- 4. Broken Axle No. 2; KPB File 2023-134
McLane Consulting Group / Taeschner
Location: Remote
Halibut Cove Area**

**ITEM #4 - PRELIMINARY PLAT
Broken Axle No. 2**

KPB File No.	2023-134
Plat Committee Meeting:	December 11, 2023
Applicant / Owner:	Kip Taeschner of Soldotna AK
Surveyor:	James Hall / McLane Consulting LLC
General Location:	Halibut Cove

BROKEN AXLE No. 2
A RESUBDIVISION OF LOT 5, BROKEN AXLE SUBDIVISION (HM2006-29)

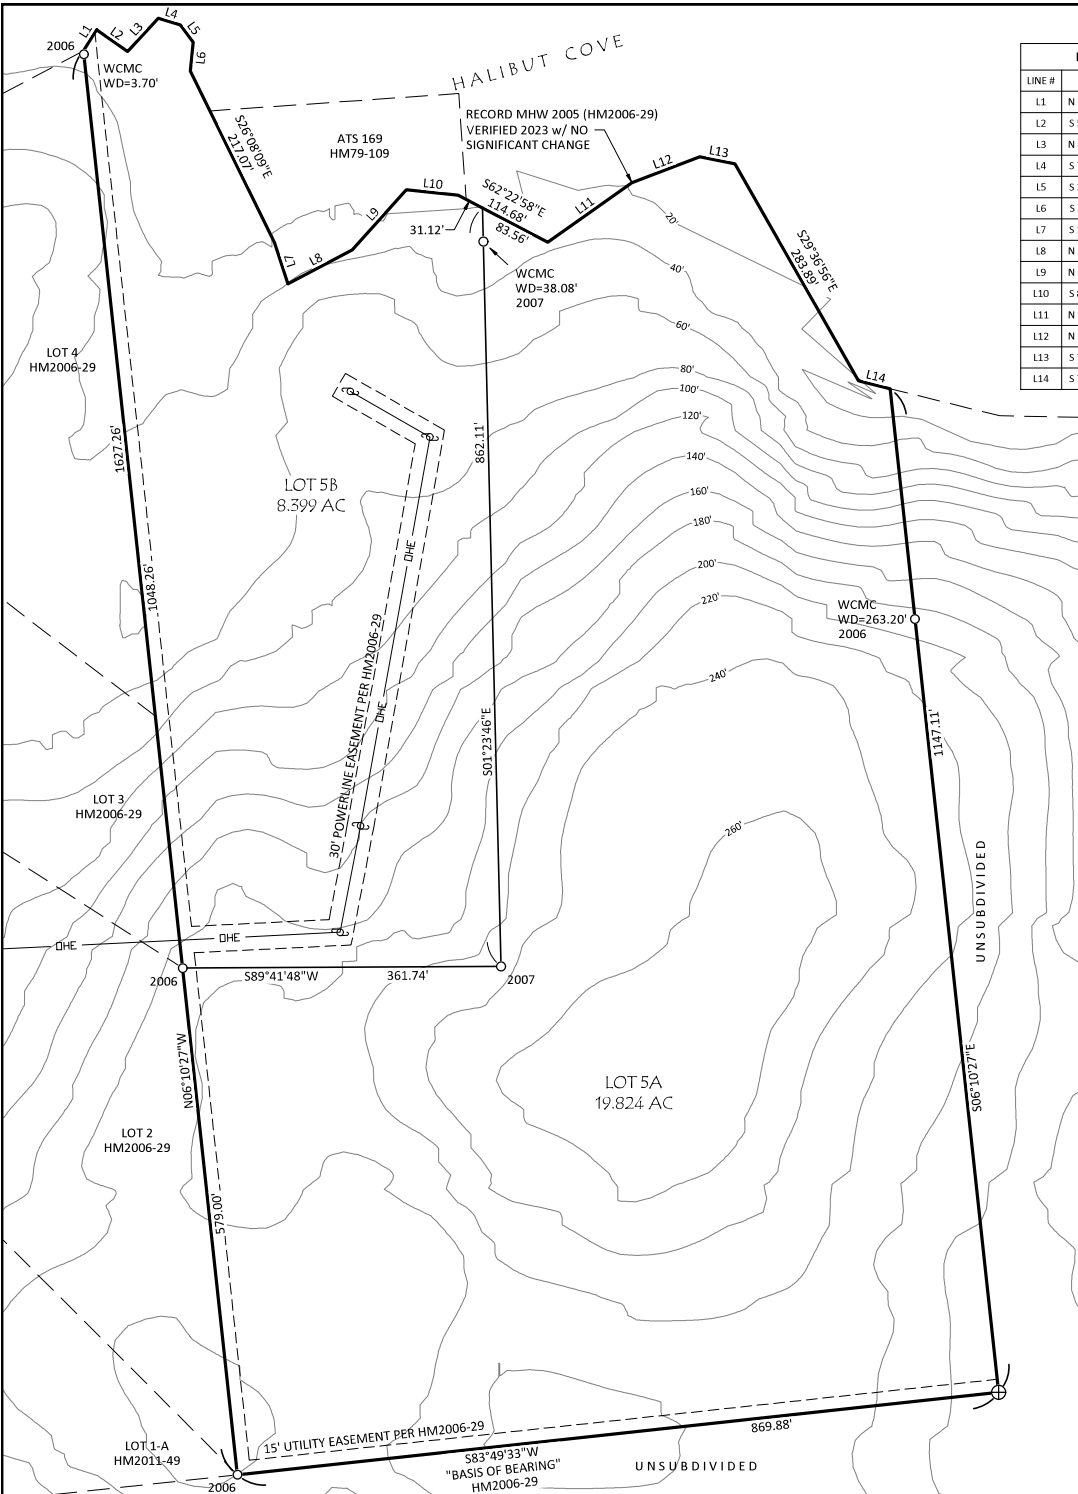
Location and Legal Access (existing and proposed): The subdivision is located on the mainland part of the Halibut Cove area across from Ismailof Island. Access to the plat will be by boat, landing at a private dock. **Staff recommends** a plat note be added stating that access to the subdivision will be by water.

Contours have been supplied on the drawing and indicate there is steep terrain on the property. **Staff recommends:** the surveyor label on the final top and toe or steep terrain on the final and contours can be removed.

Improvements are shown on the Alaska Tidal Survey. The surveyor should locate any structures near the boundary lines for encroachment issues and if found provide a remedy for the problem.

The affected utility providers were emailed the subdivision plat public hearing notice as part of the routine notification process. **Staff recommends** to grant utility easements requested by the utility providers or work with the utility providers to obtain approval.

Add 134 to KPB File no 2023-xxx

- M. Approximate locations of slopes over 20 percent in grade and if contours are shown, the areas of the contours that exceed 20 percent grade shall be clearly labeled as such;
Staff recommendation:
Top and toe / steep slope need identified on drawing.
- N. Apparent encroachments, with a statement indicating how the encroachments will be resolved prior to final plat approval;
Staff recommendation:
ATS 169 shows structures, confirm location when doing field work.

Staff recommendation: Place the following notes on the plat.

- The borough will not enforce private covenants, easements, or deed restrictions per KPB 20.60.170.
- The natural meanders of ordinary high water (or mean high water line as applicable) is for area computations only, the true corners being on the extension of the sidelines and the intersection with the natural meanders.

Add to the Plat Approval December 11

Change the date to 2024 on the Notary's Acknowledgement as completion is estimated to be after January 1, 2024.
